TO: Mercedes-Benz Dealer Principals, General Managers, Sales Managers, Service Managers, Parts Managers	FROM: Gregory Gunther, Senior Manager, Vehicle Compliance and Analysis, Engineering Services
RE: <b>Recall Campaign Launch Notification</b> <b>Check Transmission Wiring Harness Routing</b> <b>MY24 E-Class (2 14)</b>	DATE: May 3, 2024

Campaign No. 2024040007, April 2024

SUBJECT: **Model E-Class (214 platform)**  
**Model Year 2024**

**Check Transmission Wiring Harness Routing**

Figure 1 – **Red (A):** Power supply line  
**Green (B):** Signal wires

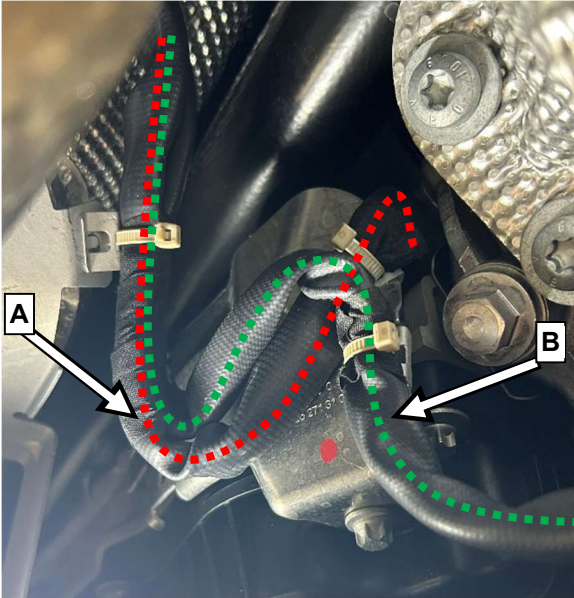
1. Check routing (**Figure 1**) and distance (**Figure 2**) between electrical wiring harnesses and the transmission tunnel/drive shaft and the transfer case to front axle differential (indicated parts).

**i** The electrical wiring harnesses **must not** be in contact with the transfer case to front axle differential.

- a. Electrical wiring harness is in contact with indicated parts but is **not damaged**: Carry out **Work Procedure 1**.
- b. Electrical wiring harness is in contact with indicated parts and **is damaged**: Carry out **Work Procedure 2**:  
**Work Procedure 2a:** Only protective sheathing is damaged.  
**Work Procedure 2b:** Signal lines (Figure 1, B) are damaged.
- c. Electrical **power supply line** (Figure 1, A) (line cross-section **10 mm<sup>2</sup>**) **is damaged**: Carry out **Work Procedure 3**.
- d. Electrical wiring harness is **routed correctly**: **End Measure**.

Figure 2

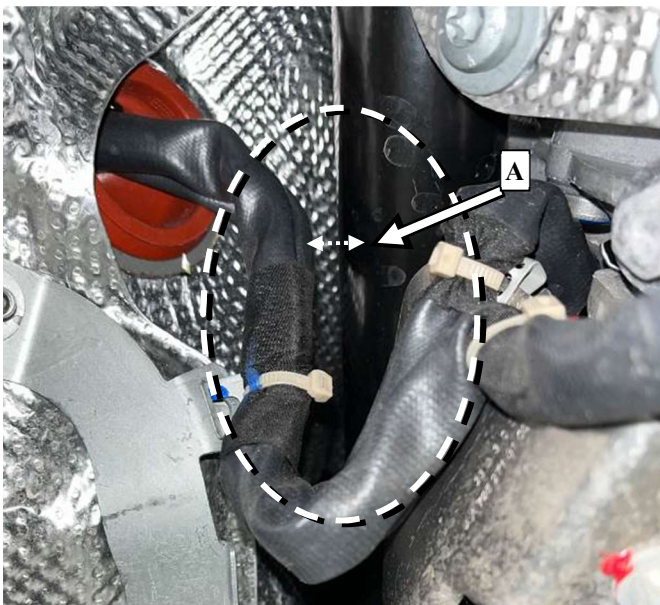
**i** The distance between the electrical wiring harness and the drive shaft **must be** at least **10 mm (Figure 2, A)**.

**Figure 3**

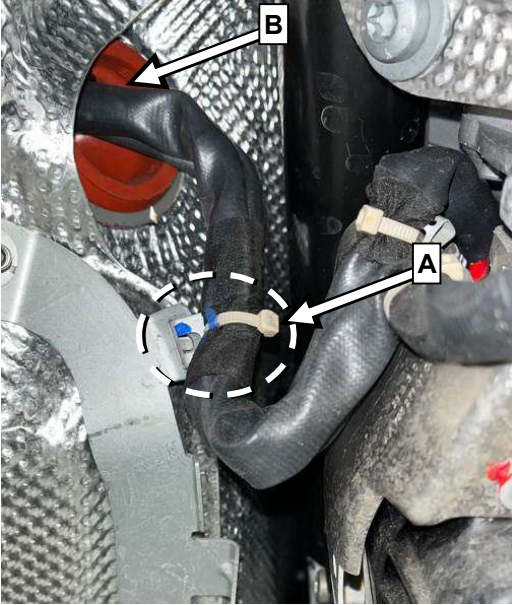
1. Cut cable tie at first clip (**Figure 3, A**).

2. Adjust length of electrical wiring harnesses between red grommet (**Figure 3, B**) and first clip (**Figure 3, A**) as shown.
  - i** The length must be between **90 mm and max 100 mm** from the first clip (**Figure 3, A**) to the red grommet.
  - i** The electrical wiring harnesses **must not be** in contact with indicated parts.
3. Fasten both electrical wiring harnesses to first clip (**Figure 3, A**) with a new cable tie.
  - i** The electrical wiring harness **must not be** in contact with indicated parts in **any location**.

**Figure 4**

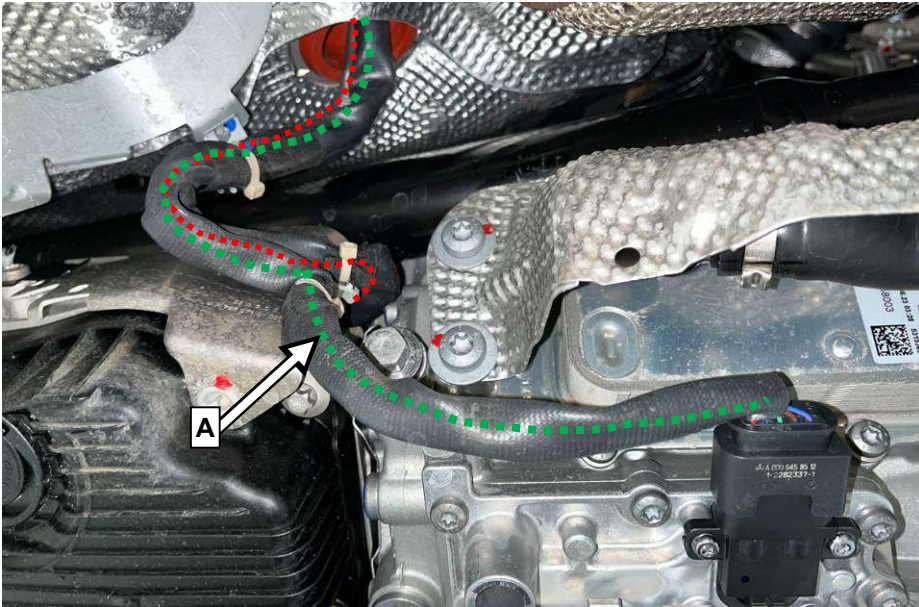
1. Wrap affected area with fabric tape.
2. Route electrical wiring harness (**Figure 4, A**) correctly as shown  
**i** The electrical wiring harness (**Figure 4, A**) must not be in contact with indicated parts ***in any location***.

- i** One or more of the electrical signal lines (**line cross section 0.35 mm<sup>2</sup> to 0.75 mm<sup>2</sup>**) in the electrical wiring harness (**Figure 4, A**) shows signs of damage.

1. Remove rear section of underfloor paneling.  
**i** For basic information, see **AR61.30-P-1001WT**.
2. Repair the respective affected electrical signal line (**line cross section 0.35 mm<sup>2</sup> to 0.75 mm<sup>2</sup>**) in the electrical wiring harness (**Figure 4, A**) using a line connector.  
**i** For basic information, see **AR00.19-P-0100A**.  
**i** To do this, cut the protective sheathing, repair wire harness using a line connector, and reinstall the protective sheathing using fabric tape to connect the cut sides.
3. Route electrical wiring harness (**Figure 4, A**) correctly as shown.  
**i** The electrical wiring harness (**Figure 4, A**) ***must not be*** in contact with indicated parts ***in any location***.
4. Assemble in reverse order.

Figure 5

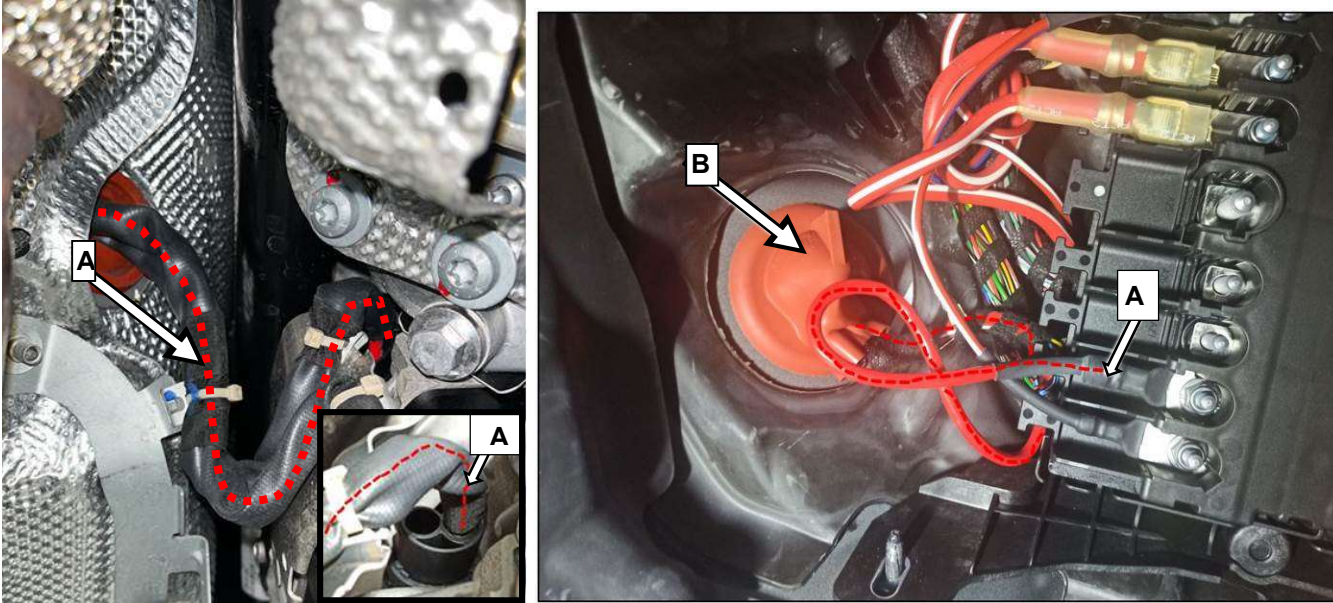
**i** If the electrical power supply line (Figure 5, A) (line cross section 10 mm<sup>2</sup>) is damaged, replace electrical power supply line (Figure 5, A):

1. Disconnect ground line of 12 V on-board electrical system battery.  
**i** For basic information, see **AR54.10-P-0051WT**.
2. Remove rear section of underfloor paneling.  
**i** For basic information, see **AR61.30-P-1001WT**.
3. Remove protective metal sheet (Figure 6, A).
4. Disconnect electrical power supply line (Figure 5, A) from electrical connector at transmission.
5. Remove front floor covering at front passenger side.  
**i** For basic information, see **AR68.80-P-0008WT**.
6. Remove electrical power supply line (Figure 5, A) with grommet (Figure 5, B).
7. Replace electrical power supply line (Figure 5, A).  
**i** The electrical wiring harness **must not** be in contact with indicated parts at **any location**.
8. Assemble in reverse order.
